PURCHASER'S EXTRAS QUOTATION

Castlemore Crossing - Phase 8 Forestside

| LOT NUMBER | PHASE | HOUSE TYPE |
|------------|-------|---------------------------------|
| 45 | 8 | SILVER POPLAR (40-02C) - ELEV C |

CONSTRUCTION SCHEDULING APPROVAL

KITCHEN

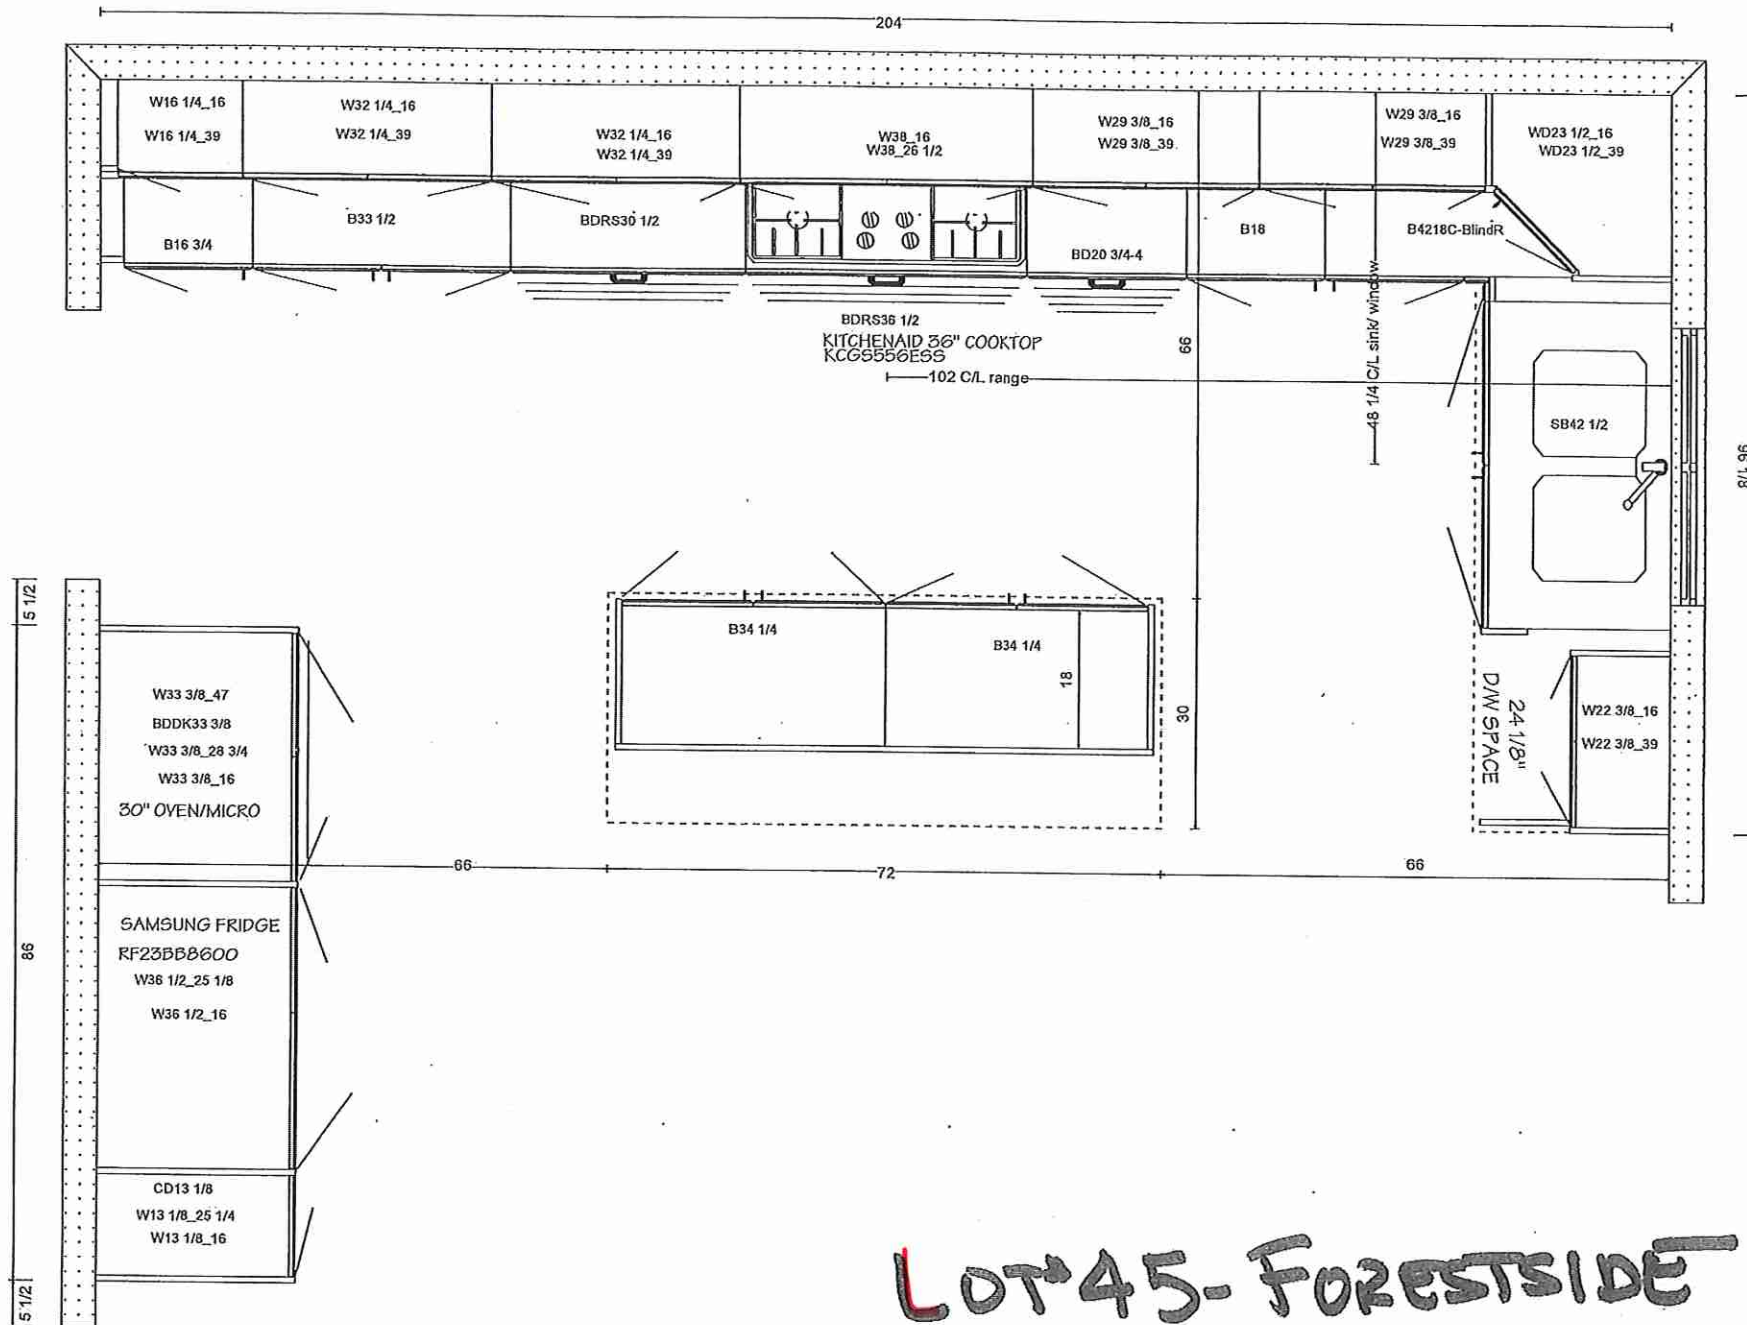
| 1 - KITCHEN- Accommodate cabinetry for a 36" Cook top (See Sketch) Note: **SEE SPECS ATTACHED** **See Villa Layout** |
| 1 - KITCHEN- Accommodate the cabinetry for a built in 27" oven and micro (See Sketch) Note: **SEE SPECS ATTACHED** **See Villa Layout** |
| 1 - KITCHEN- Install an upper diagonal corner (See Sketch) Note: **See Villa Layout** |
| 12 - KITCHEN- Install plain clear glass for the top of each Stacked Upper Cabinet, including the Diagonal corner (See Sketch) Note: **See Villa Layout** |
| 1 - KITCHEN - CABINETRY - Install OPEN LIGHT VALANCE MOULDING - To be installed below upper cabinetry, where applicable (See Sketch) Note: **See Villa Layout** |
| 1 - KITCHEN - CABINTRY - Install Extended Height Stacked Uppers with Large Crown Moudling, Pan and Fascia - To reach the ceiling (See Sketch) Note: **See Villa Layout** |

FRIDGE WALL

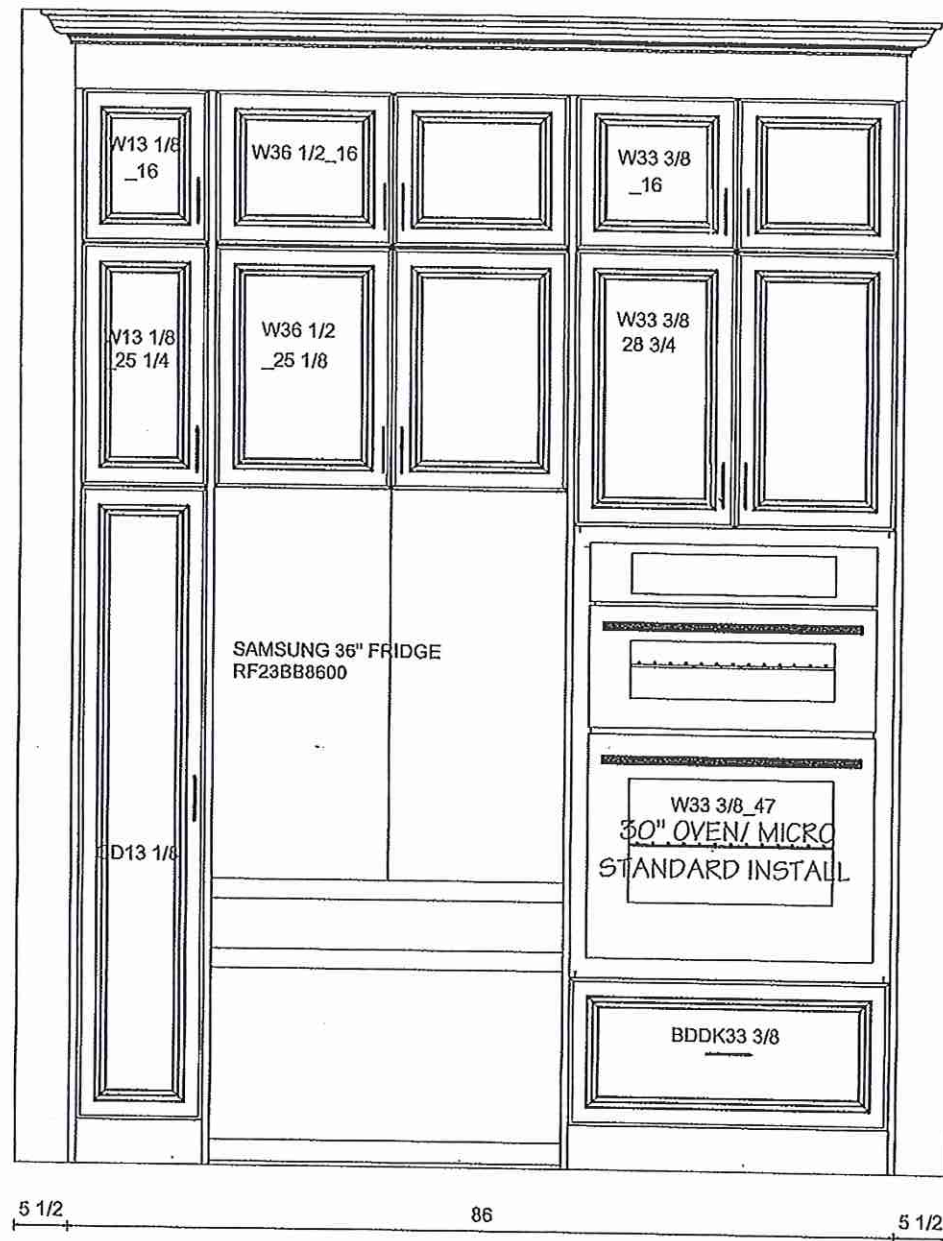
| 1 - KITCHEN - CABINETRY - Install FULL DEPTH FRIDGE ENCLOSURE (Includes Applicable Gables) (See Sketch) Note: **See Villa Layout** |

1 - KITCHEN- Purchasers request to shift the Pantry in the kitchen and the Fridge (including the electrical) towards the kitchen entrance. (See Sketch)
Note: ****PLEASE NOTE**** Additional upper/lower/& standard counter top to be charged and added at time of colour chart if needed, once the kitchen has been designed. Purchaser accepts & acknowledges that the above price does NOT include additional upper and lower cabinetry & builders standard counter top

SINK WALL

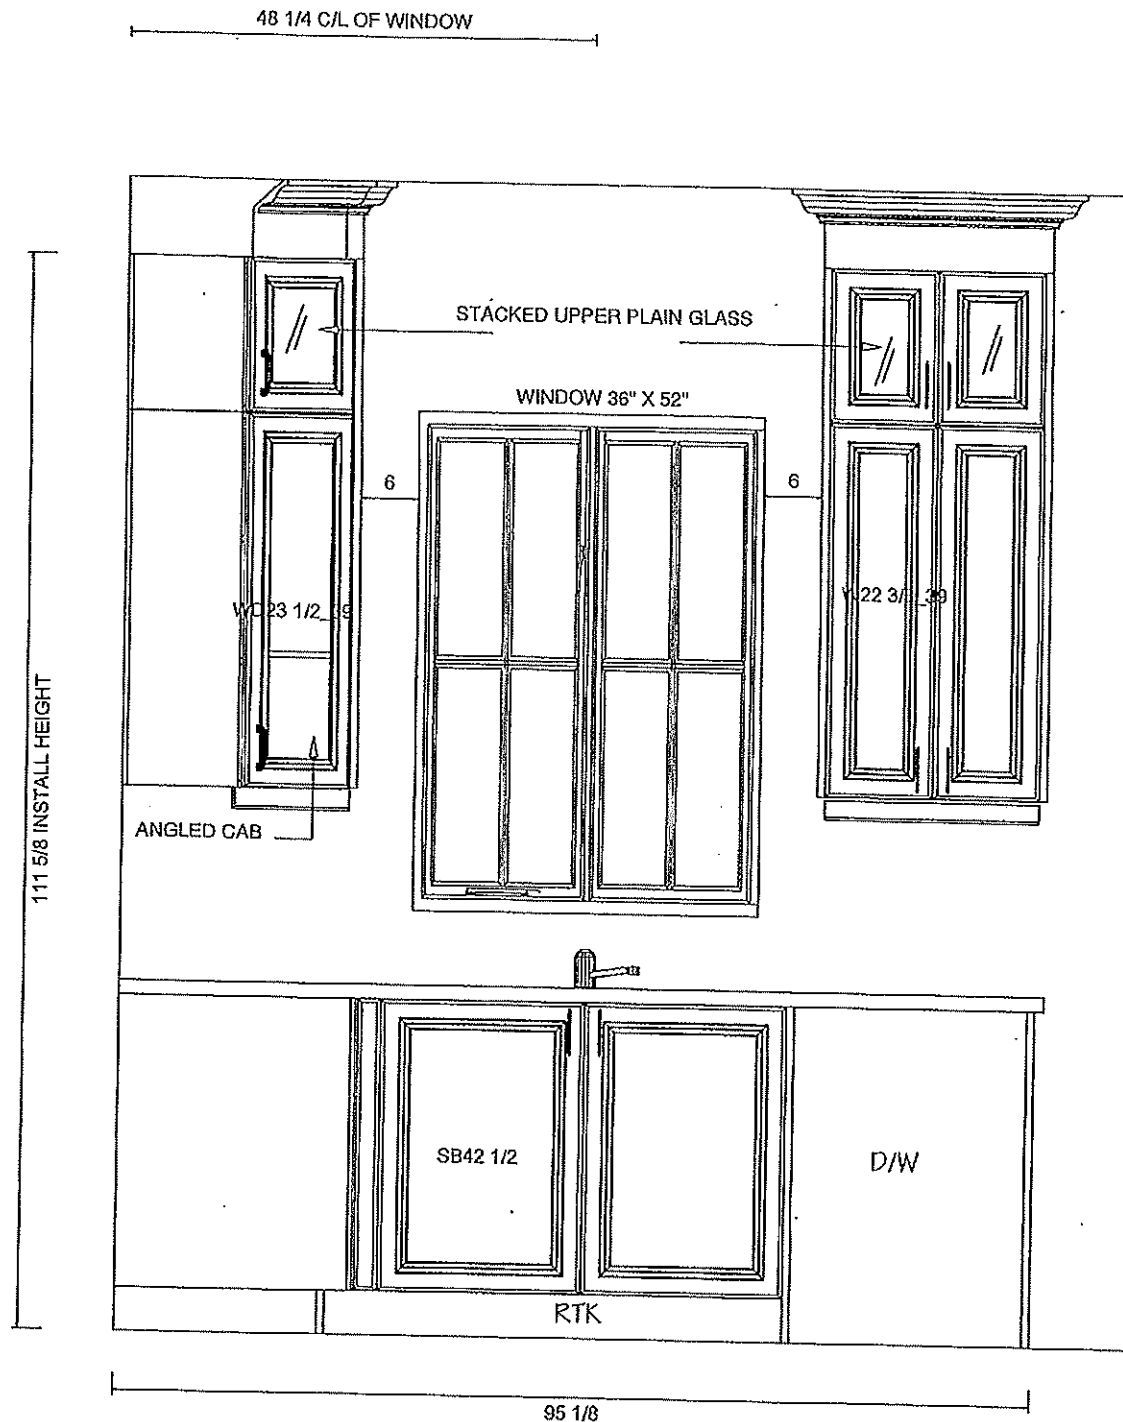
ALL STACKED UPPERS ON THIS WALL PLAIN GLASS DOOR

ISLAND

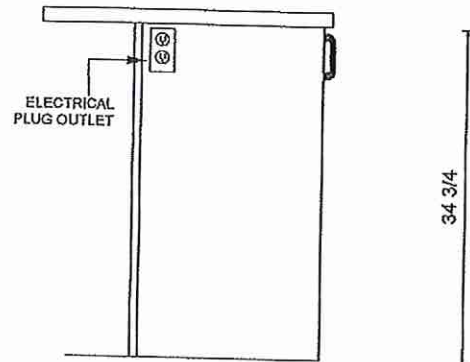
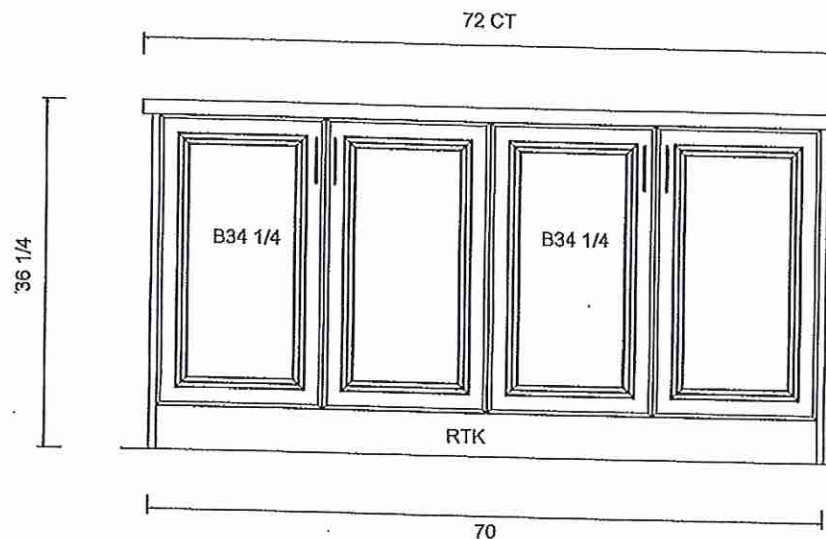
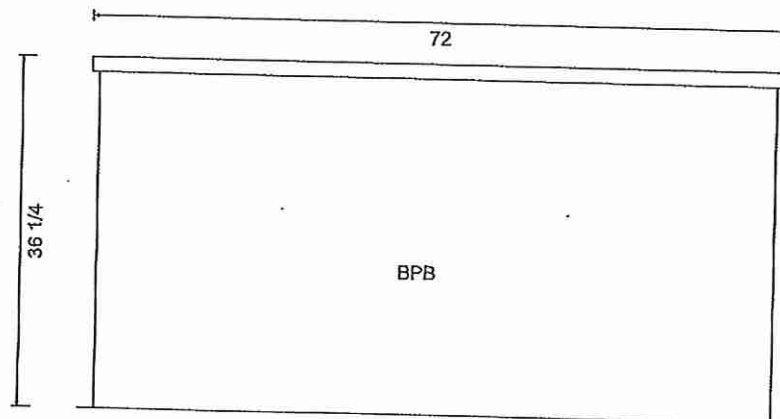
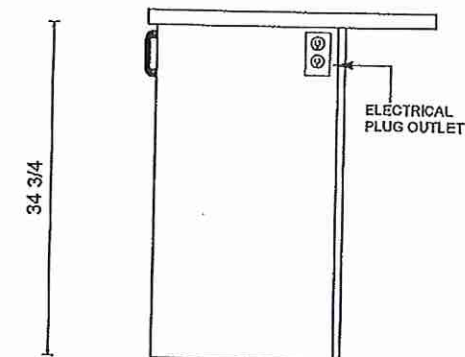
OUTLET LOCATION ON ISLAND TBD
FOR THE OWNER PRIOR PRODUCTION

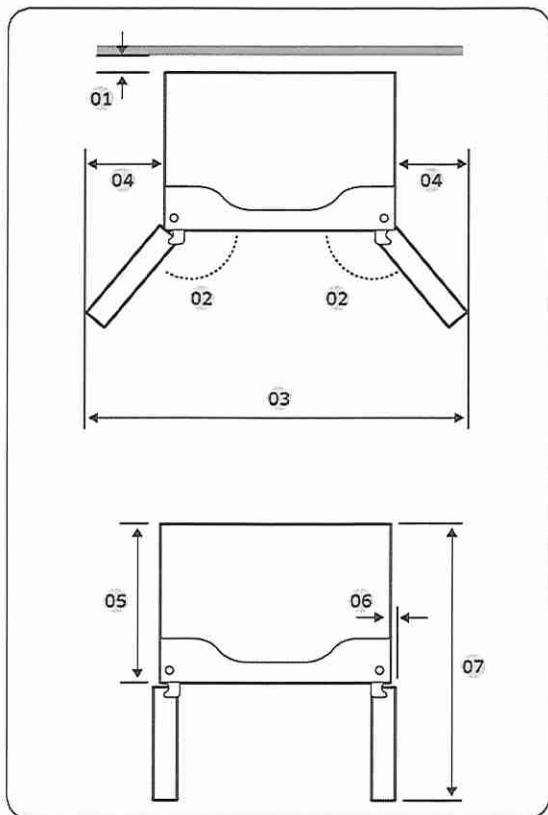
| 1 - KITCHEN- Purchasers request to NOT Install a water Lline Rough for the future fridge. Purchaser to accommodate after closing Note: |

No Water Line

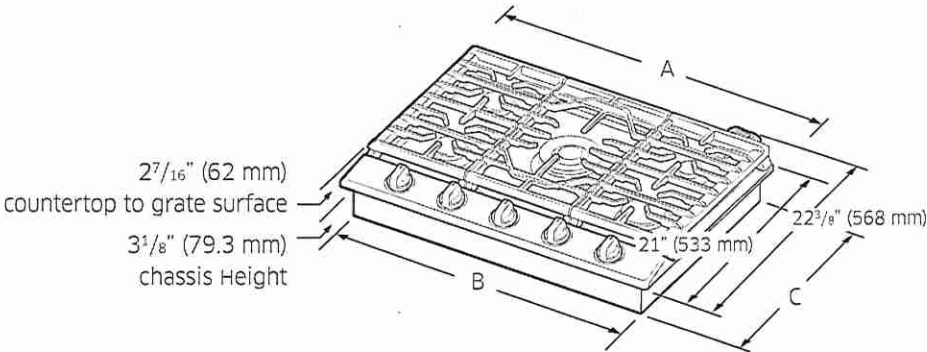
| 1 - KITCHEN- Purchasers request to NOT Install a Gas lline Rough for the future Gas Cook Top. Purchaser to accommodate after closing. Note: |

No Gas Line
